## The Progress Power (Gas Fired Power Station) Order

# APPLICATION TO MAKE A NON MATERIAL CHANGE TO THE PROGRESS POWER (GAS FIRED GENERATING STATION) ORDER

**PINS Reference Number:** EN010060  
**Document Reference:** NMC  
**Regulation Number:** Regulation 4  
**Author:** Progress Power Limited

EAST ELEVATION

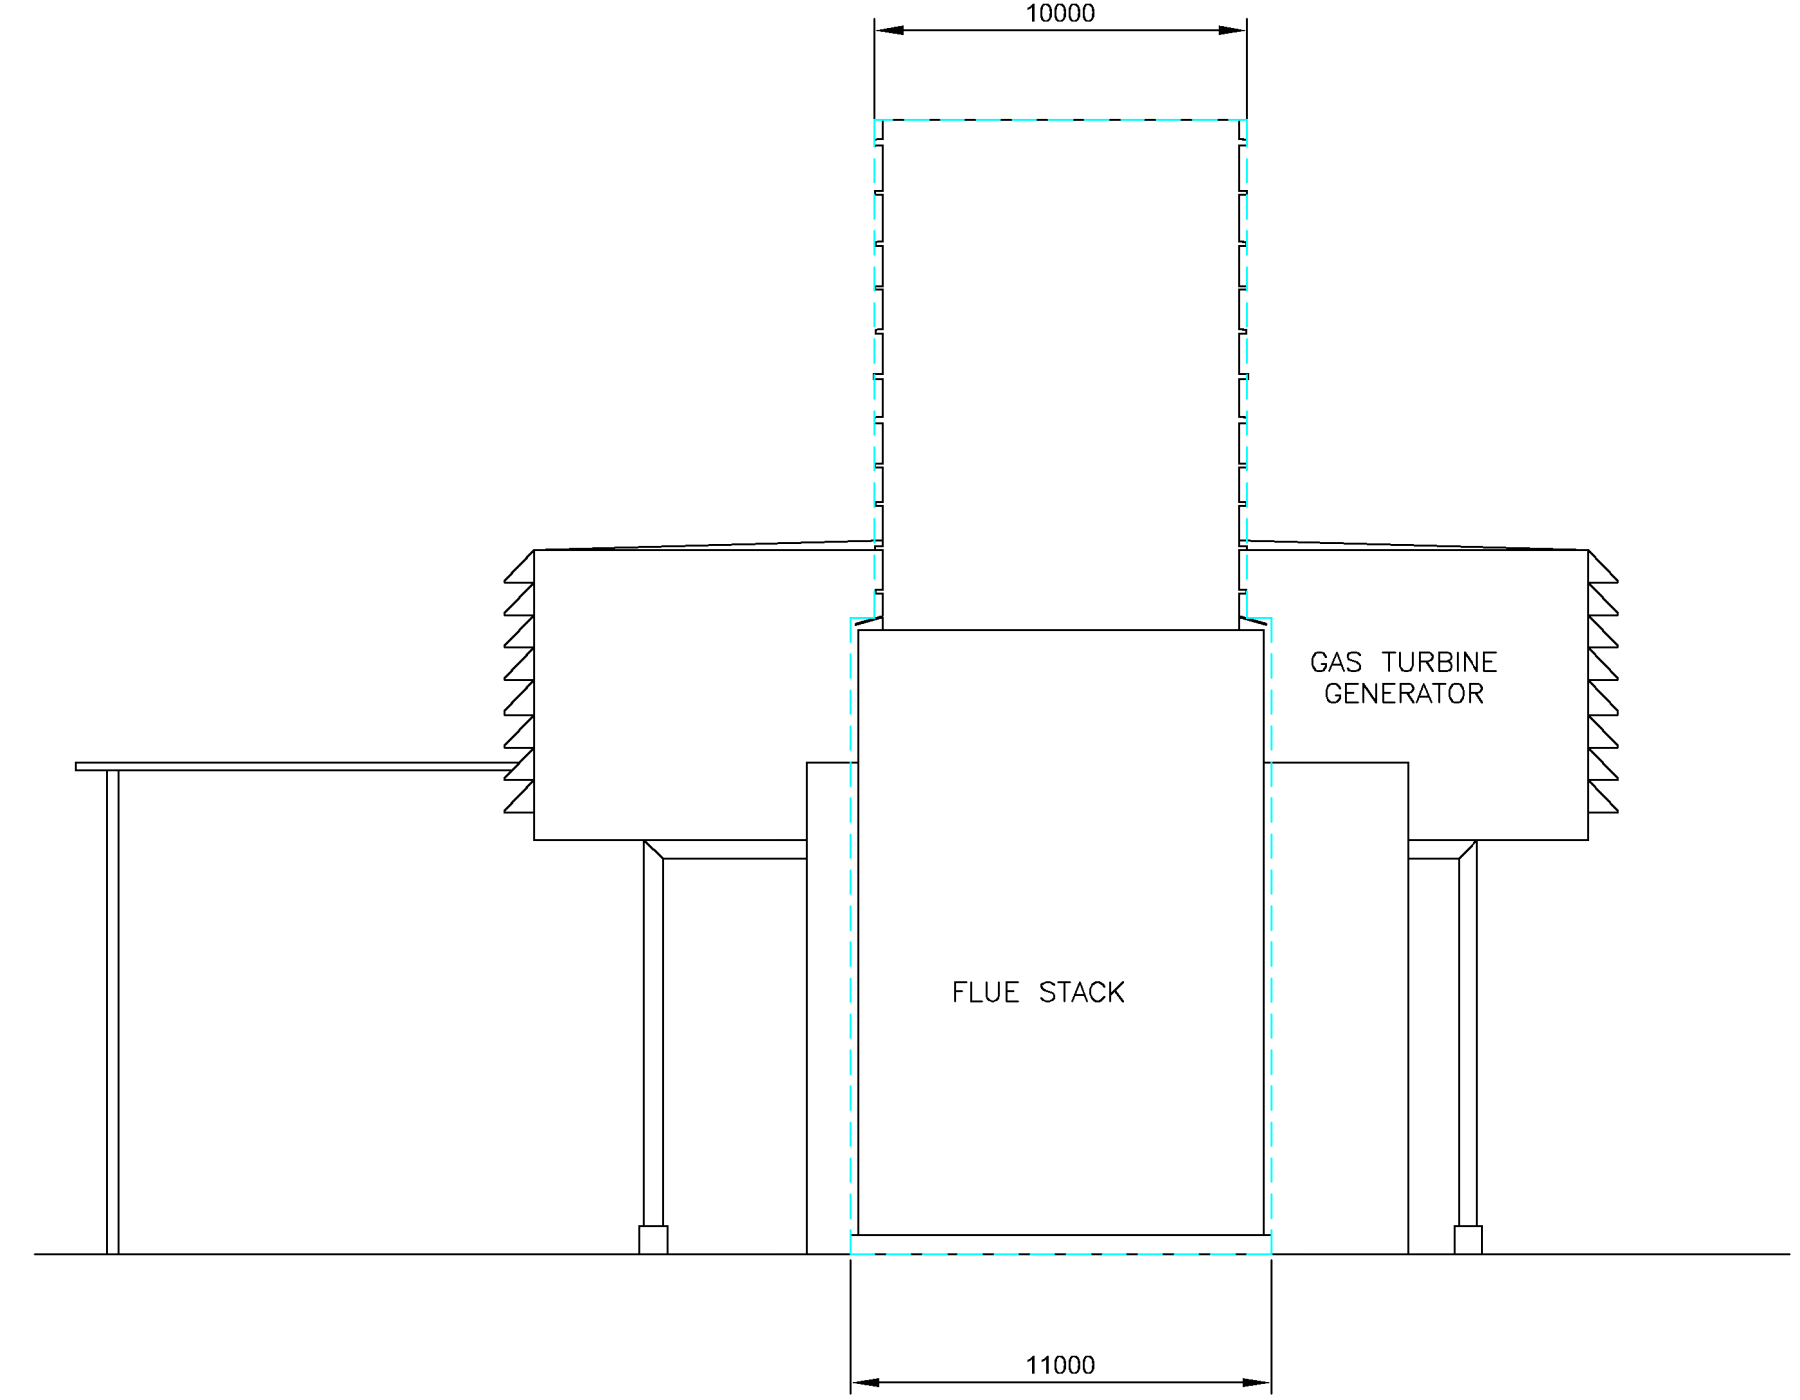
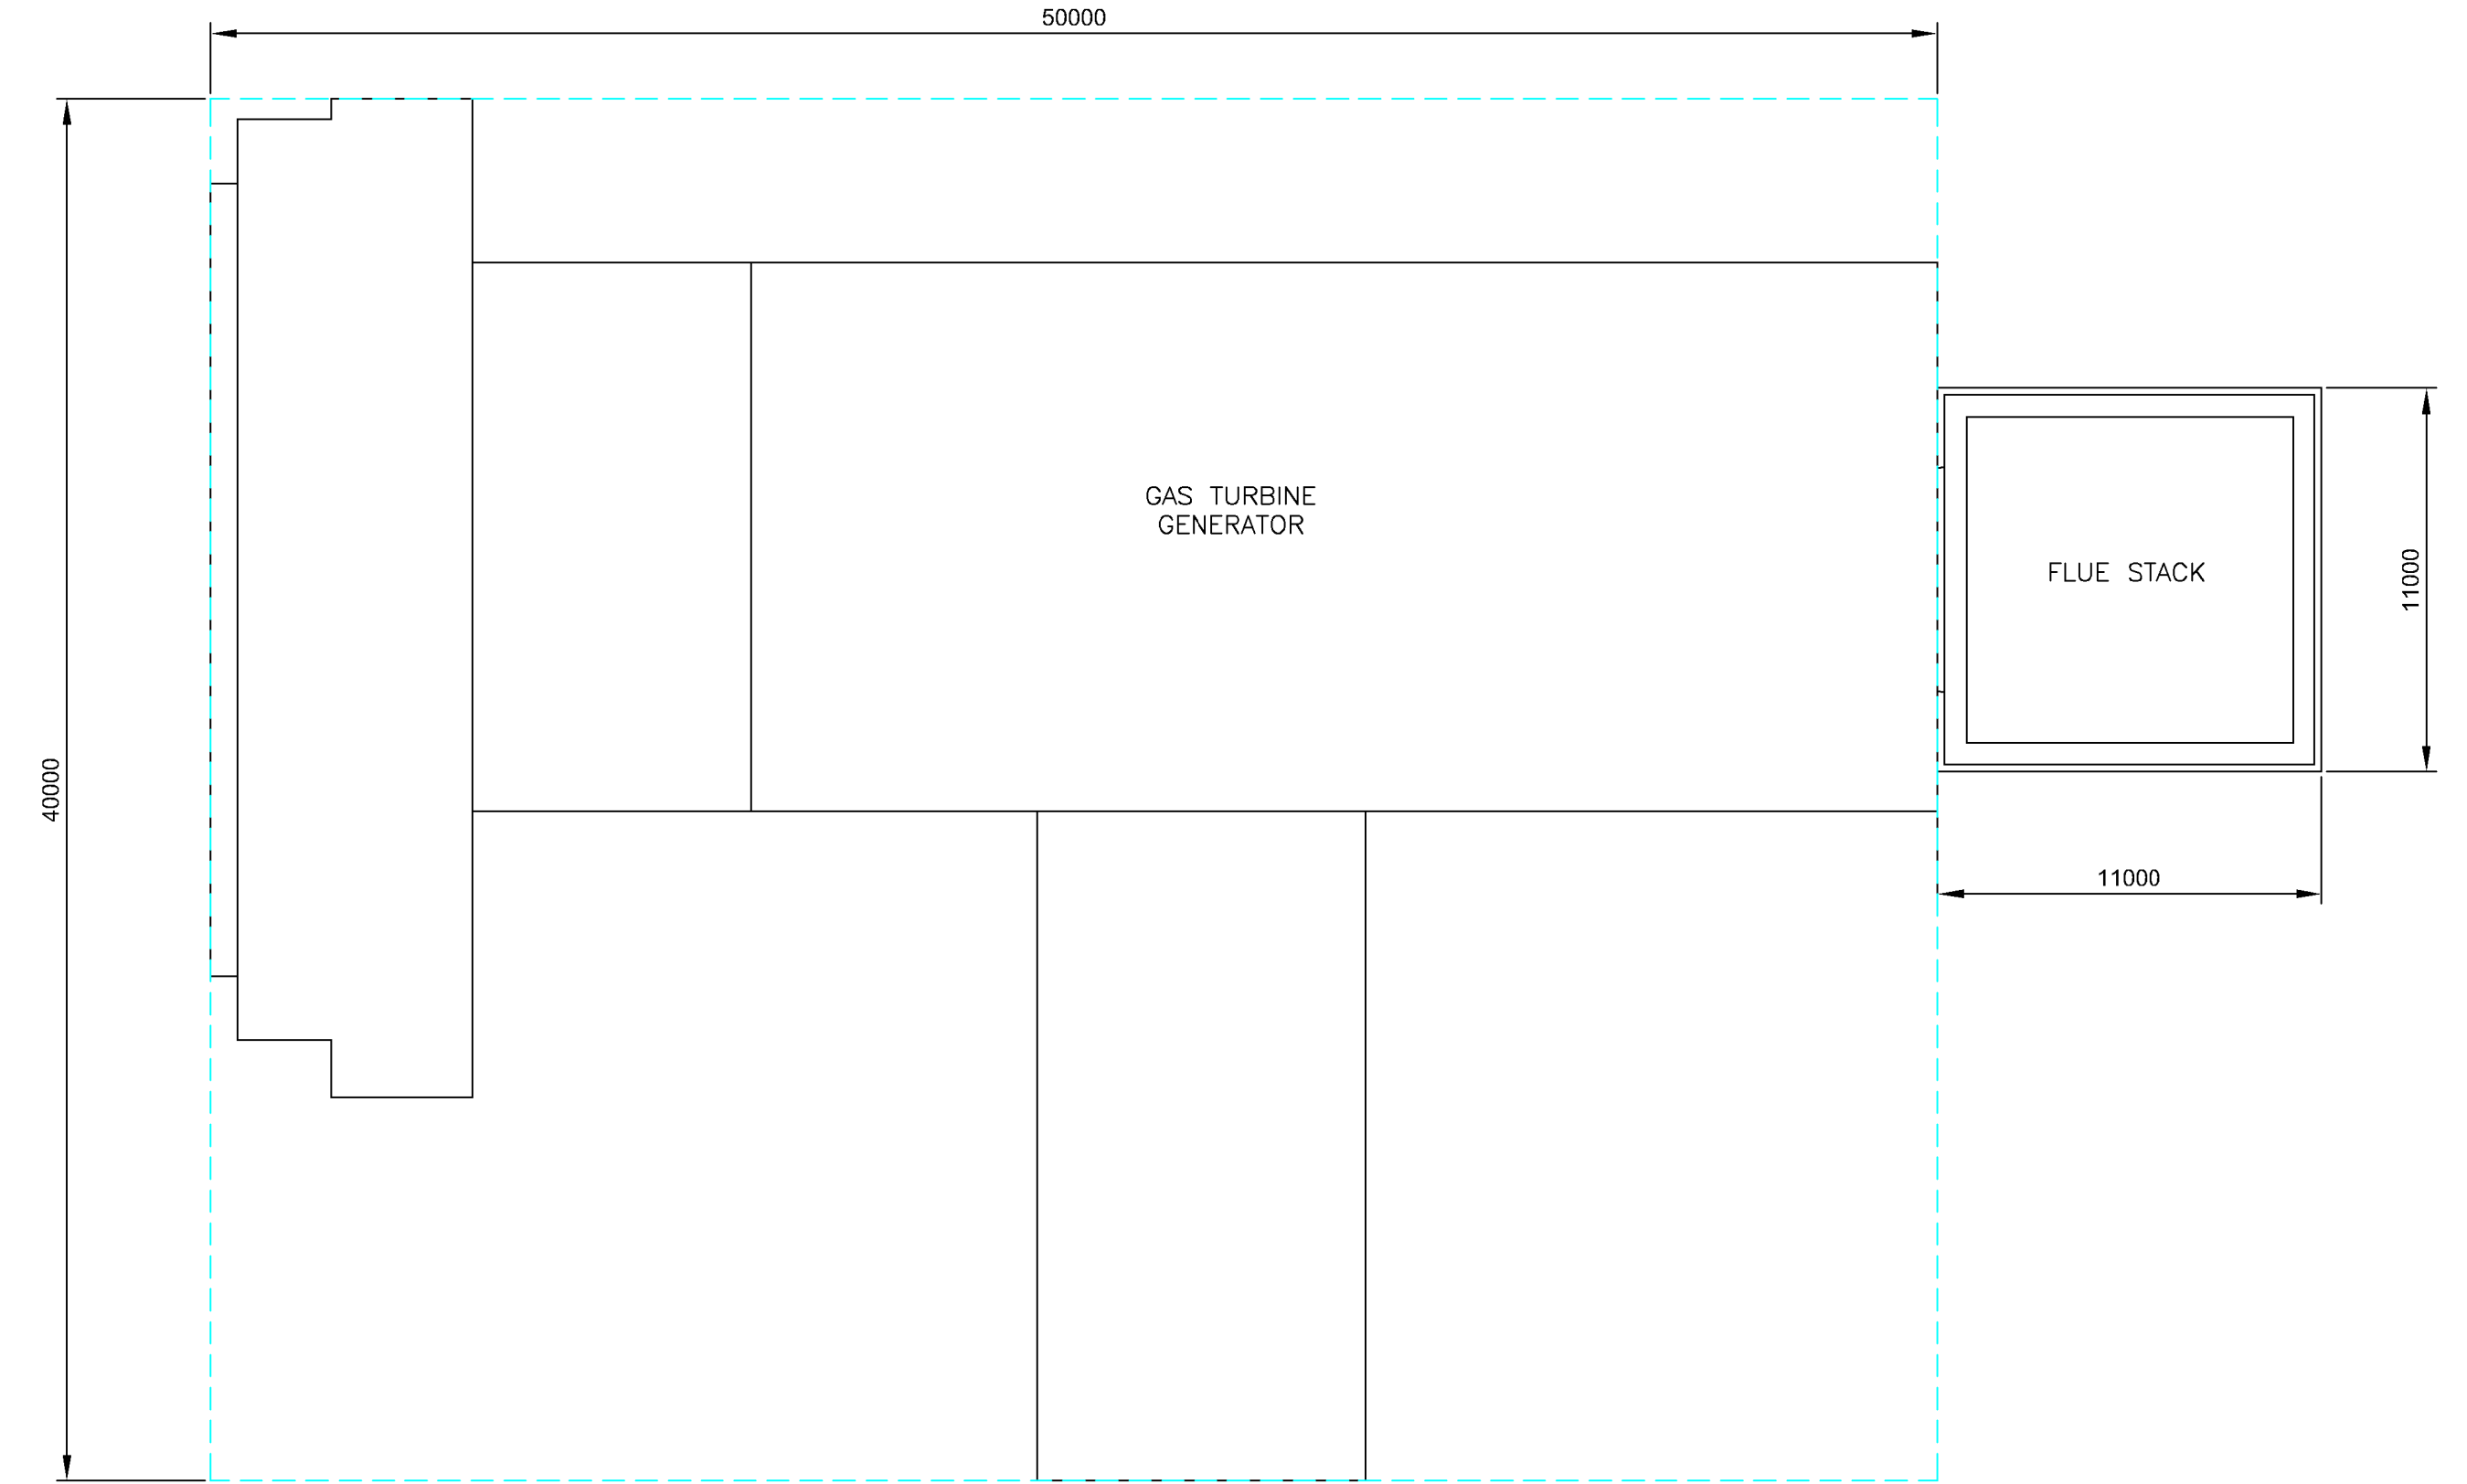
4.2.3 In summary, for **the one GTG solution only**, there is a need to increase the length of the GTG from a maximum of 30 metres to 50 metres to accommodate the diffuser system elements of the GTG and the width from a maximum of 30 metres to 40 metres to accommodate the lube oil system. This would involve a change to Table 2 in Requirement 3, Schedule 2 of the Order. However, there would be no change in the overall footprint of the Power Generation Plant as

4.3.2 At present, the Order does not account for this difference in width between the two sections of the flue stack. Accordingly, there is a need to increase the width of the flue stack from 8.4 metres to 11 metres up to and including a height of 16.5 metres AOD and from 8.4 metres to 10 metres thereafter to a height of 30 metres. The increase in the stack width for the upper section is required to enable the GTG to meet the noise limits under the Development Consent Order through the inclusion of a silencer. This would involve a change to Table 2 in Requirement 3, Schedule 2 of the Order.

Change Number	Building or Structure	Summary of what is currently authorised under the Order	Suggested Change
One	Gas Turbine Generator (GTG)	<p>Table 2, Requirement 3, Schedule 2:</p> <p>Each gas turbine generator (where one or two gas turbine generators are constructed) (Part of numbered work 1A):</p> <p>Maximum height: 19 metres above 48.5 metres AOD</p> <p>Maximum length: 30 metres</p> <p>Maximum width: 30 metres</p>	<p>Amend Table 2, Requirement 3, Schedule 2 as set out in Appendix Four so as to permit the following parameters for a single GTG scenario:</p> <p>Maximum height: 19 metres above 48.5 metres AOD</p> <p>Maximum length: 50 metres</p> <p>Maximum width: 40 metres</p>
Two	Flue Stack	<p>Table 2, Requirement 3, Schedule 2:</p> <p>Each exhaust gas emission flue stack (where one or two gas turbine generators are constructed) (part of numbered work 1A):</p> <p>Maximum height: 30 metres above 48.5 metres AOD</p>	<p>Amend Table 2, Requirement 3, Schedule 2 as set out in Appendix Four so as to permit the following parameters for a single GTG scenario:</p> <p>Maximum Width: 11.0 metres up to and including a height of 16.5 metres above 48.5m AOD and 10 metres from a height of</p>

Change Number	Building or Structure	Summary of what is currently authorised under the Order	Suggested Change
		<p>Minimum height: 25 metres above 48.5 metres AOD</p> <p>Maximum width: 8.4 metres</p>	<p>16.5 metres above 48.5m AOD to a height of 30 metres above 48.5m AOD.</p>
Three	Black start diesel generator	<p>1. Schedule 1:</p> <p>Numbered work 1B authorises development comprising....(e) black start diesel generator</p> <p>2. Table 2, Requirement 3, Schedule 2:</p> <p>Black start diesel generator (part of numbered work 1B):</p> <p>Maximum height: 5.0 metres above 48.5 metres AOD</p> <p>Maximum length: 13.0 metres</p> <p>Maximum width: 5.0 metres</p>	<p>1. Amend Schedule 1, Numbered work 1B(e) as set out in Appendix Three.</p> <p>2. Amend Table 2, Requirement 3, Schedule 2 as set out in Appendix Four so as to permit the following parameters for all GTG scenarios:</p> <p>Maximum length: 17 metres</p>

Title: **BLACK START GENERATOR PLAN & ELEVATIONS Reg5(2)(o)**

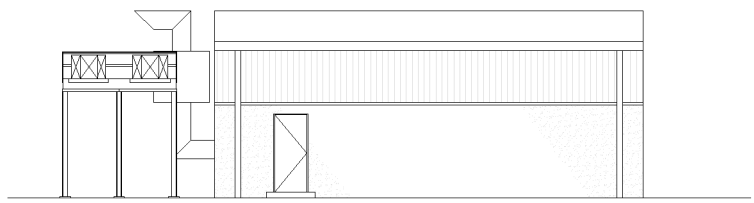
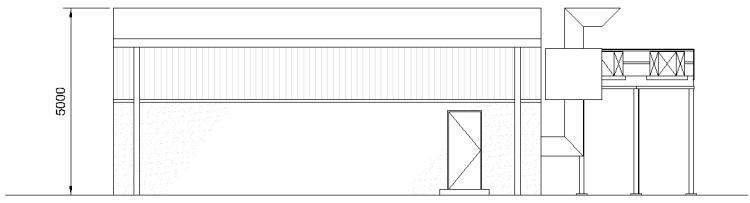
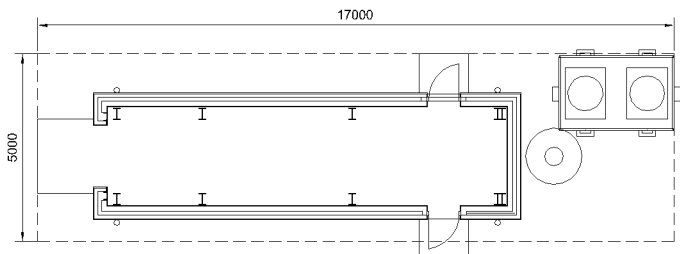
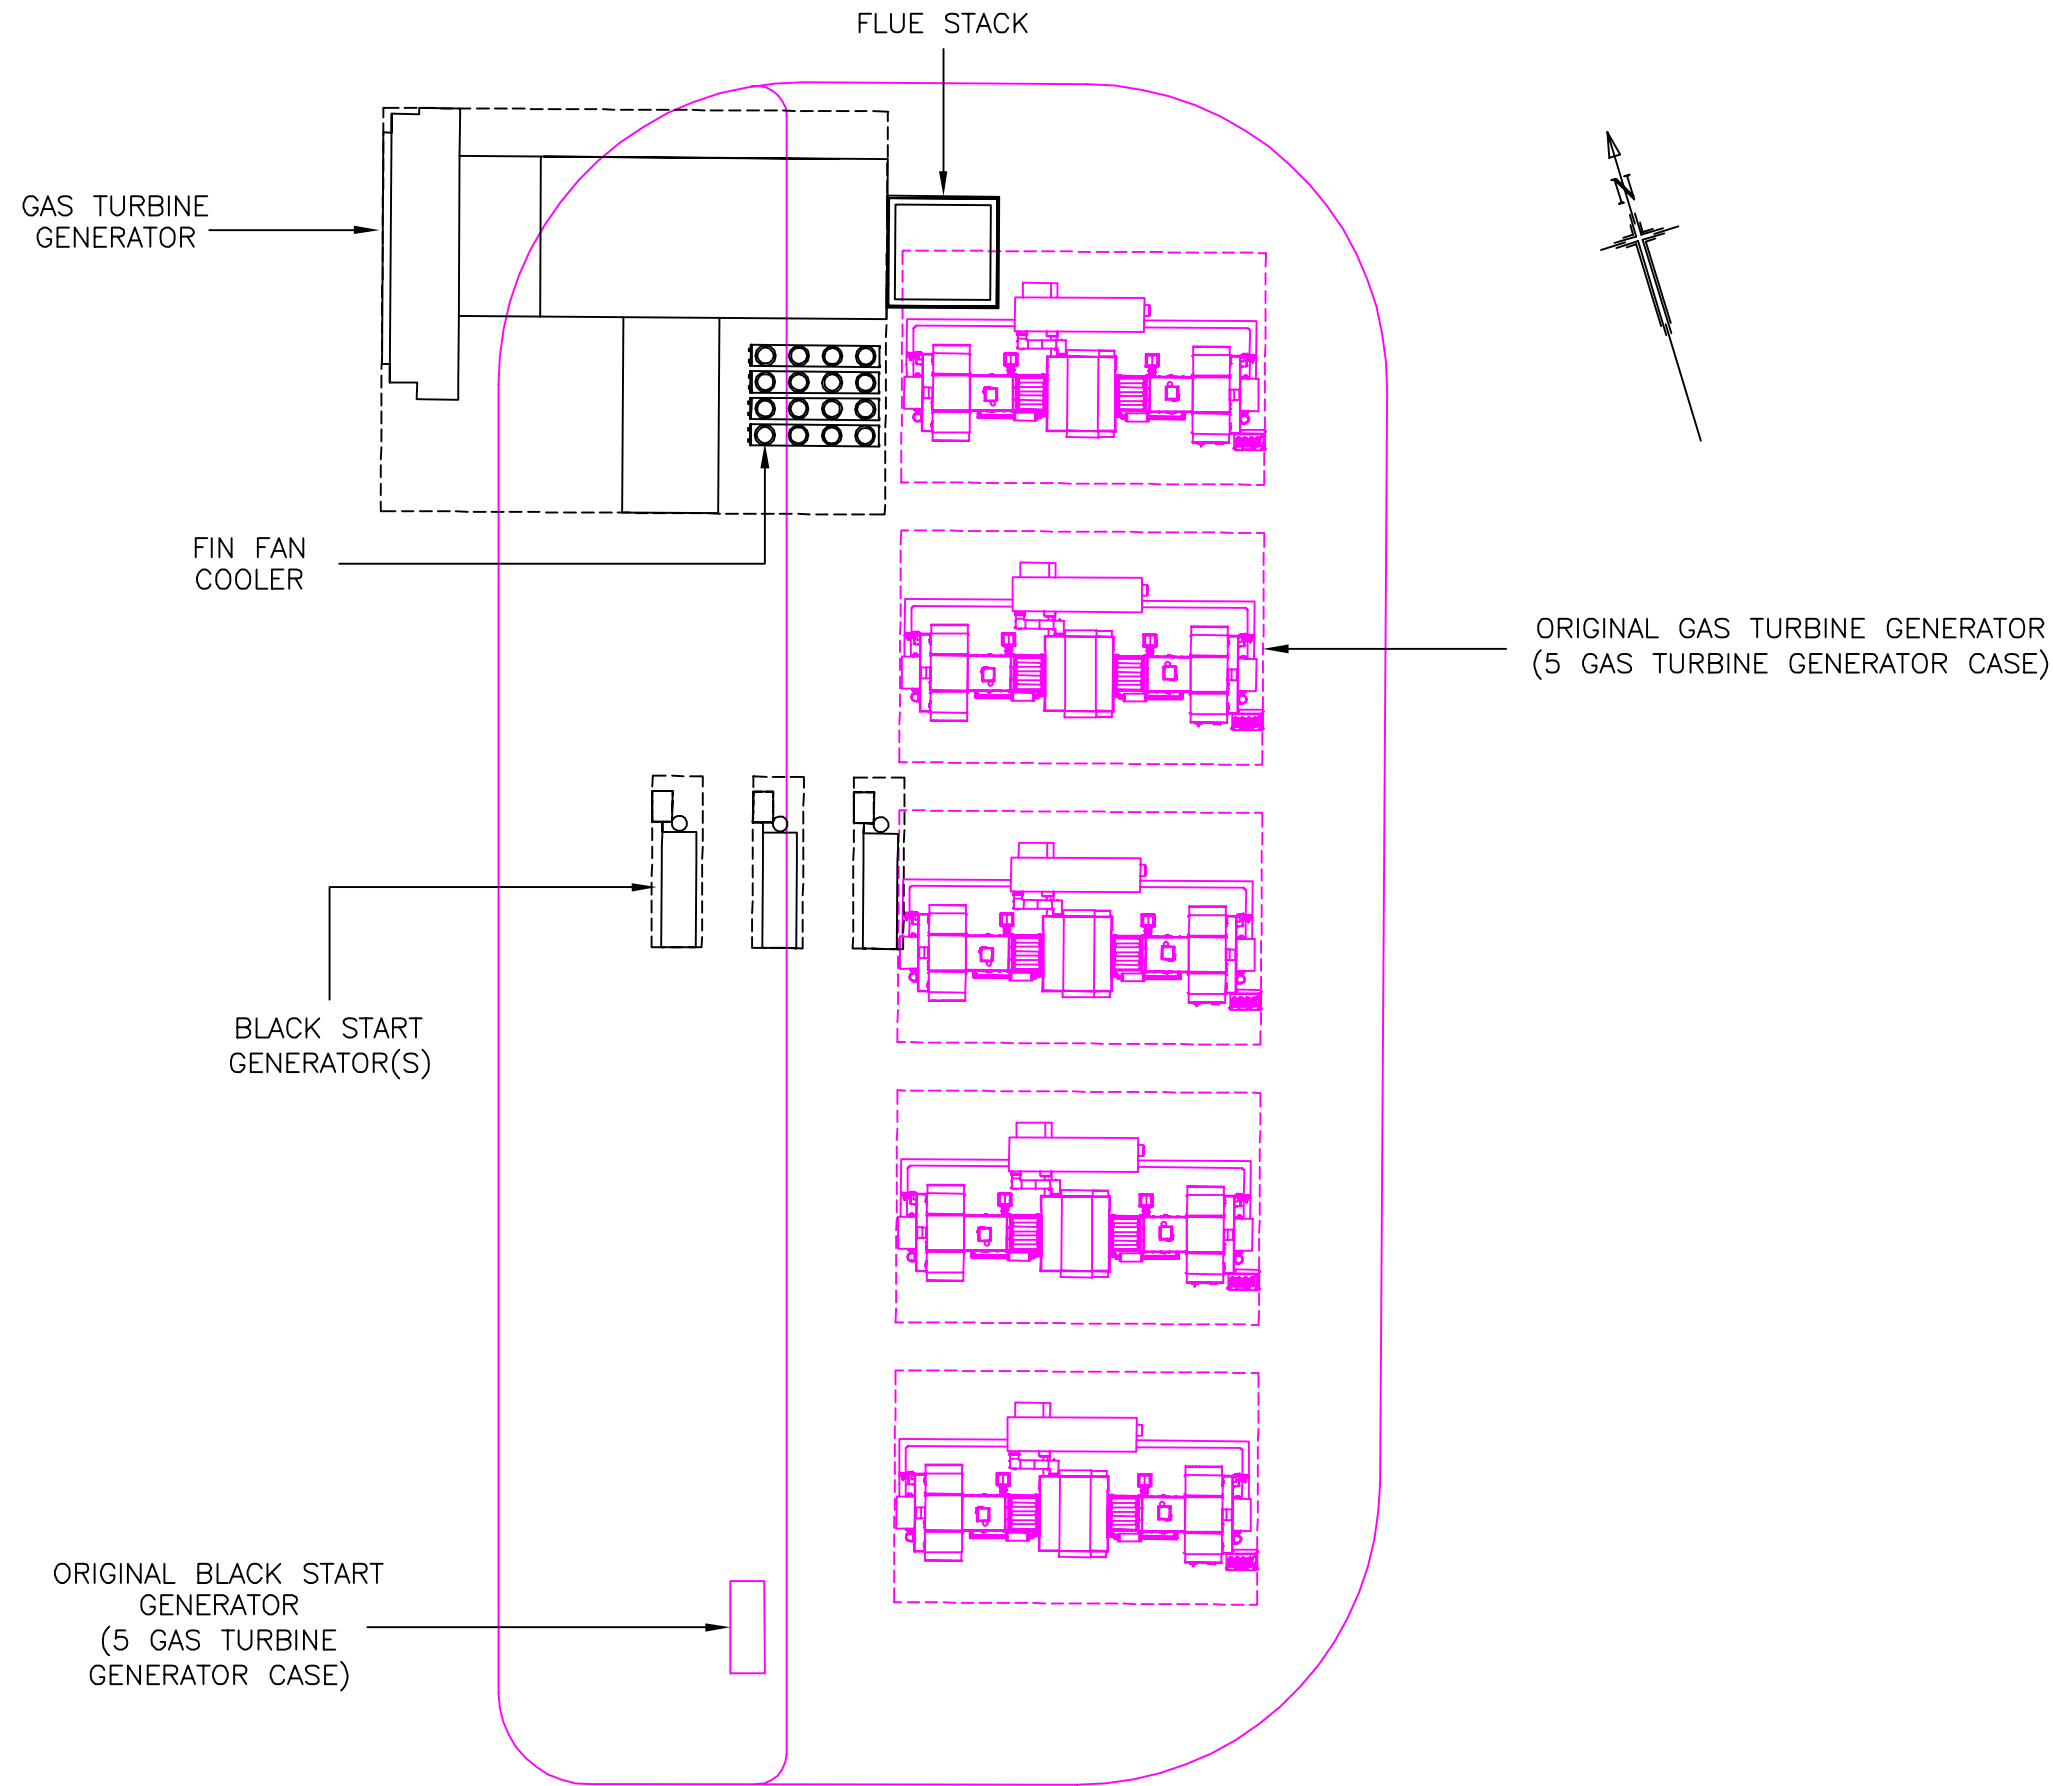
in **all GTG scenarios** the size of the black start diesel generators needs to increase in length from 13 metres to 17 metres. This would involve a change to Table 2 in Requirement 3, Schedule 2 of the Order.

3.4.3 The size of the black start diesel generator is also slightly longer than originally predicted; the length of each generator is 4 metres longer, meaning that the parameters need to increase from 13 metres to 17 metres. This applies to all GTG scenarios. This requires a change to Table 2 in Requirement 3 of Schedule 2.
